BULLETIN

**BAKERSFIELD CITY SCHOOL DISTRICT  
 BESSIE OWENS E.S. TEMPORARY RELOCATABLES**

BULLETIN NO. ONE (1) DATE: October 11, 2019

CLIENT / PROJECT: BAKERSFIELD CITY SCHOOL DISTRICT  
 BESSIE OWENS E.S. – ELECTRICAL, DATA, & FIRE ALARM FOR TEMPORARY RELOCATABLES

**E200**

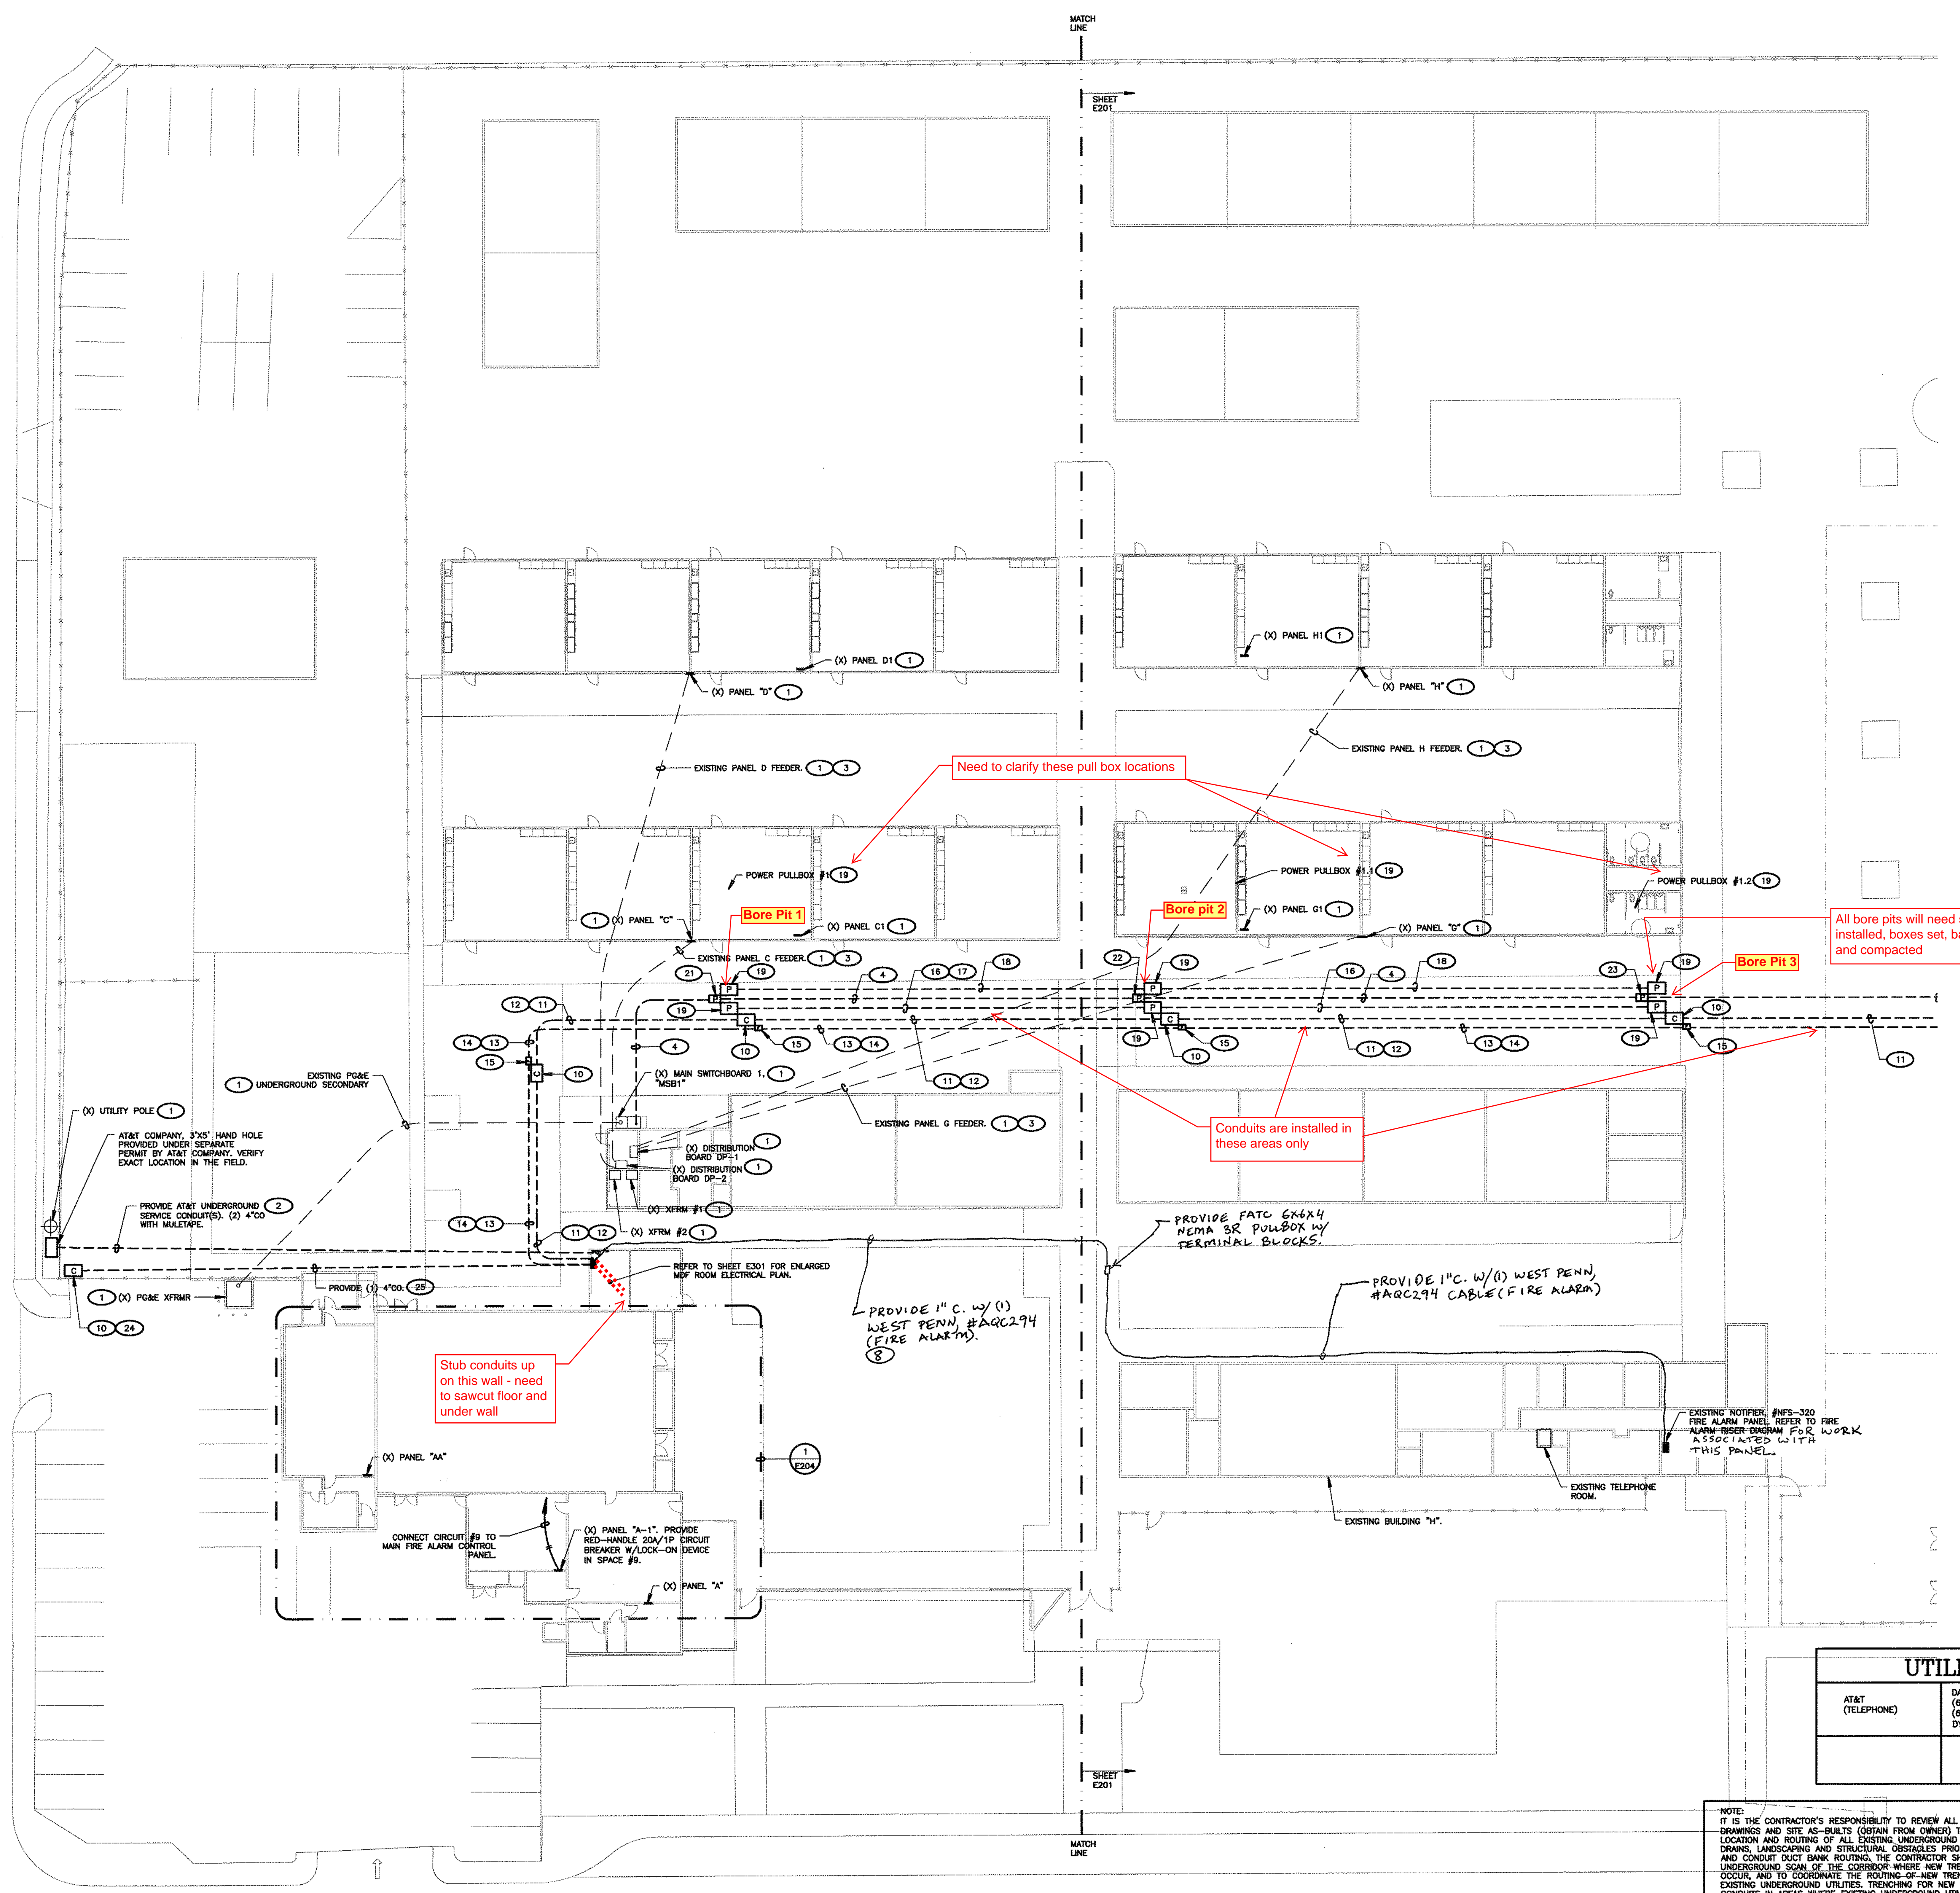
1. All other bore pits will need to be cleaned out (due to previous water inundation), conduits trimmed and turned up.
2. Conduit from west side **Bore Pit 1** to Electrical gear, and new Data Room. See attached Sheet E200, for location.
3. Conduit from **Bore Pit 6** adjacent to the south Temp Admin Relocatables and PRC Relocatable. See attached Sheet E201 and E203.

**E201**

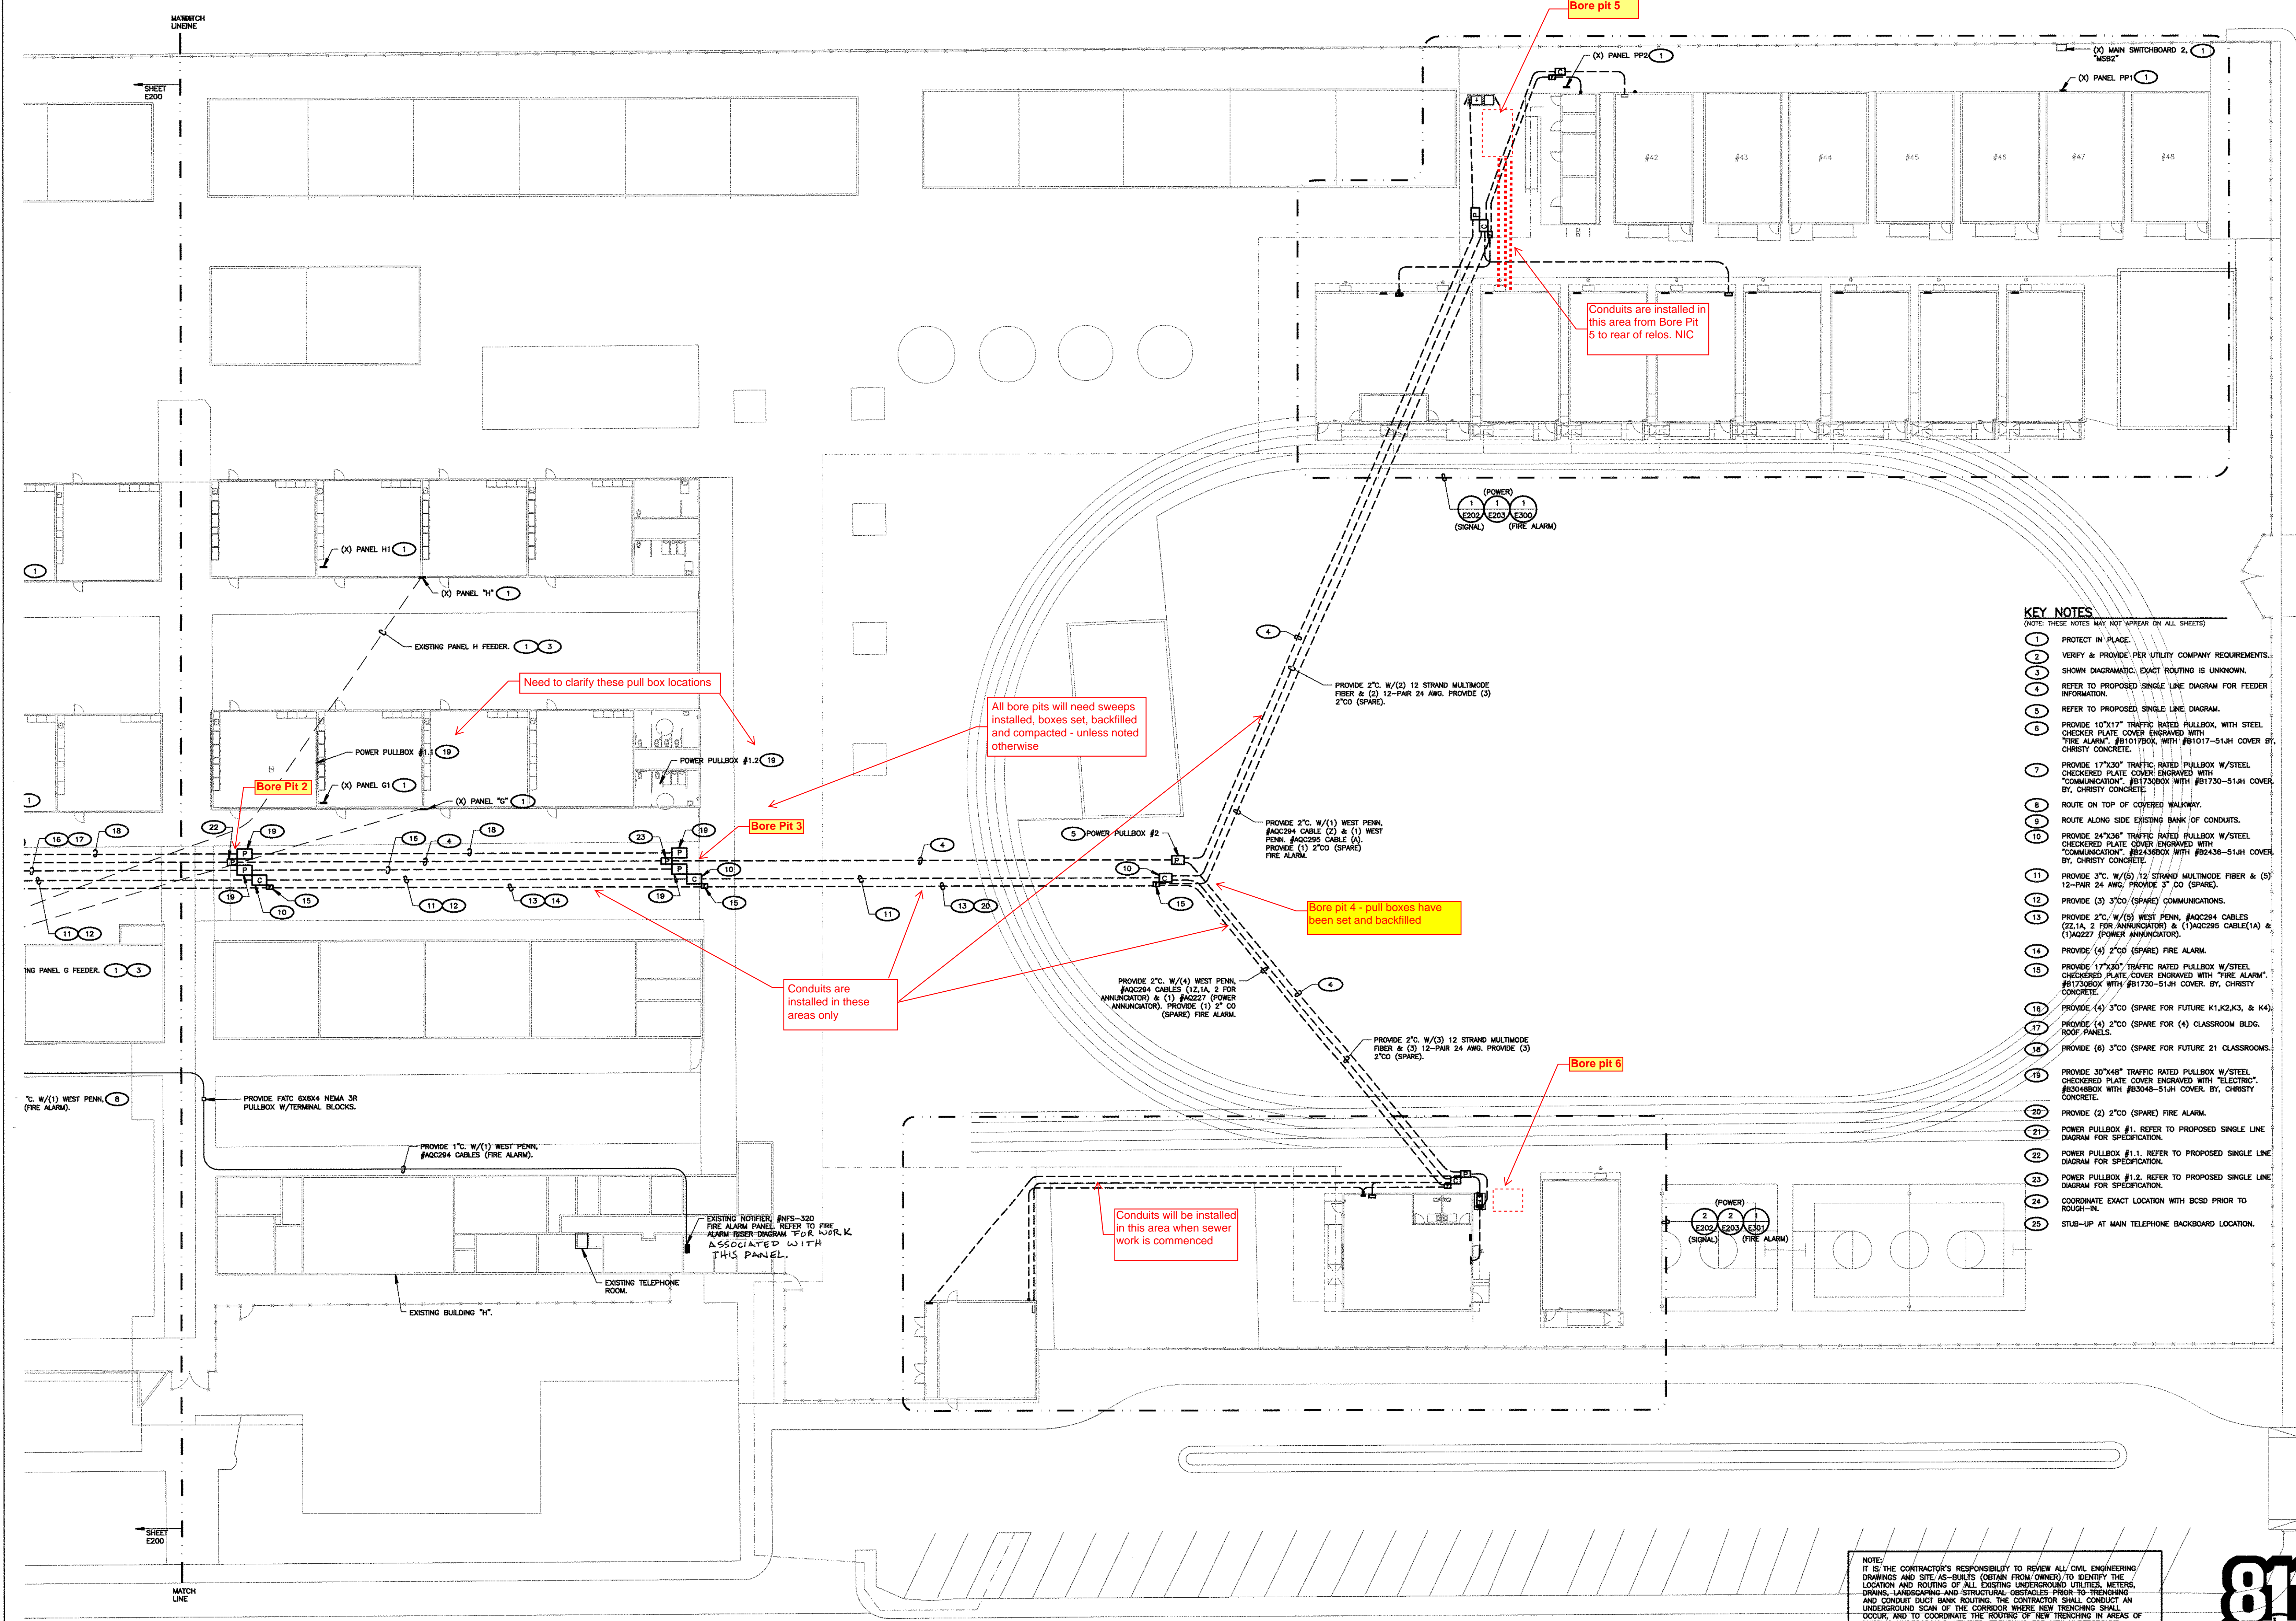
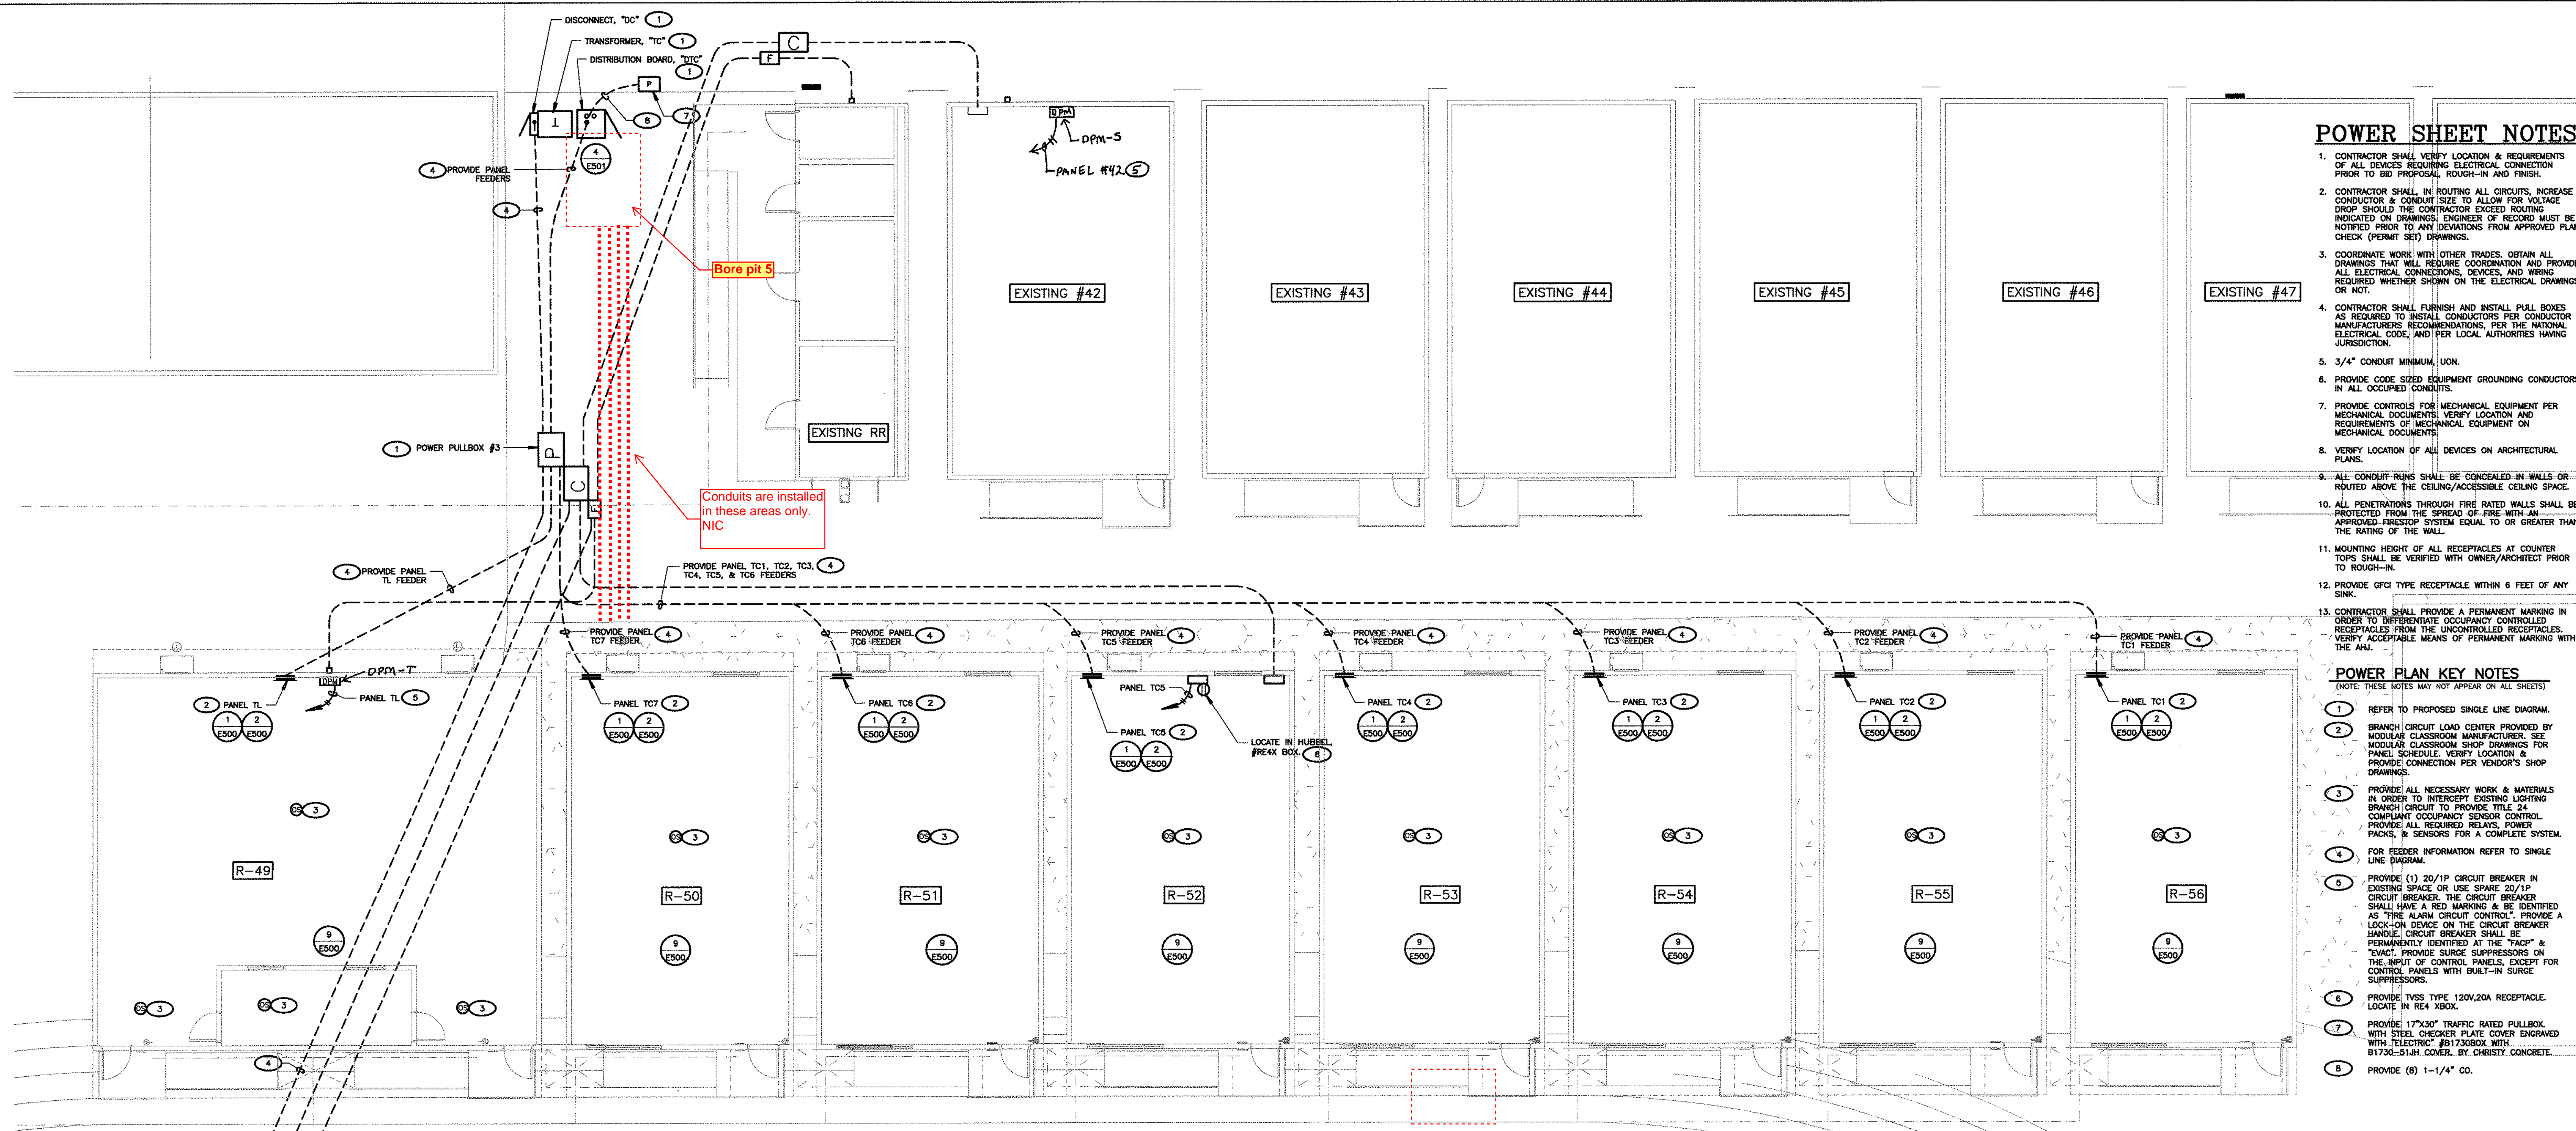
1. Relocatable Placement including foundations and ramps.
2. Underground conduit. (With the exception of items listed under "Contractor Furnished -Contractor Installed", see below).
3. Underground Pull Boxes:
  - (3) Three have been installed at Bore Pit 4, west side of track. See attached E201, for location.
